Access Compliance Report Public Rights-of-Way (RR Crossings)

Intersection ID: 5600	Main Street: N_TRYON_ST	Location: N/A
ADA ID: A77976B91A4F	Overall Compliance: No	Severity Score: 0.0
Codes/Mitigation Info/Possible Solution		Field Measurements/Component Compliance

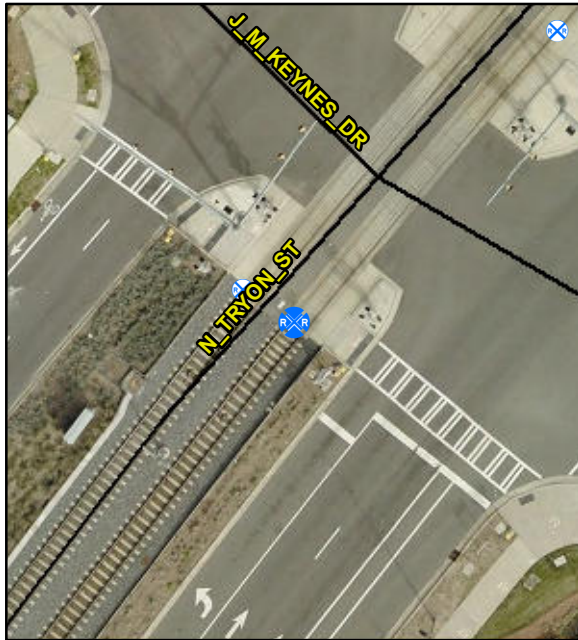
Compliance	Description	Data
No	DWS Provided?	No
N/A	DWS Contrast?	N/A
N/A	DWS Width (in)	N/A
N/A	DWS Length (in)	N/A
N/A	DWS Offset (in)	185.0
Yes	Pedestrian Gate?	Yes
N/A	DWS Outside Gate?	Yes
N/A	Rail Type?	LightRail
No	Flangeway Gap (in)	3.0
Yes	Sidewalk Width (in)	121.0

**Install Detectable Warning System.
Remove & Replace Walking Surface
Adjacent to Rail.**
